**Virginia Department of Health
Sewage Handling and Disposal Advisory Committee (SHADAC) Meeting
May 20, 2021 Summary**

Dr. Degen discussed the proposed fast-track amendments to the Sewage Handling and Disposal Regulations and comments received from the SHADAC and members of the public on the proposed amendments. Based on comments received, VDH:

1. Proposed Job Aid for Identification of a Permeability Limiting Feature (30 minutes)

Figure 1. Downward flow of effluent from the dispersal point is limited where adjacent horizons have contrasting texture, structure, consistence, or permeability, such as a Texture Group II horizon over a Texture Group IV horizon.

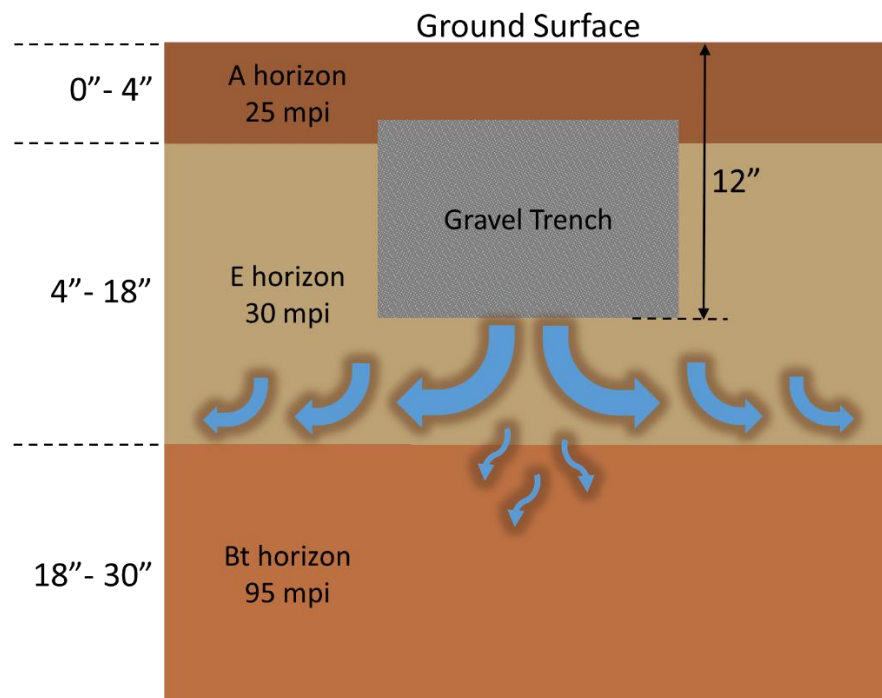
functionality. When there is a rate differential between the design rate and the slowest horizon within 18 inches, the impact should be addressed under 12VAC5 613-80.12. (See Figure 1)
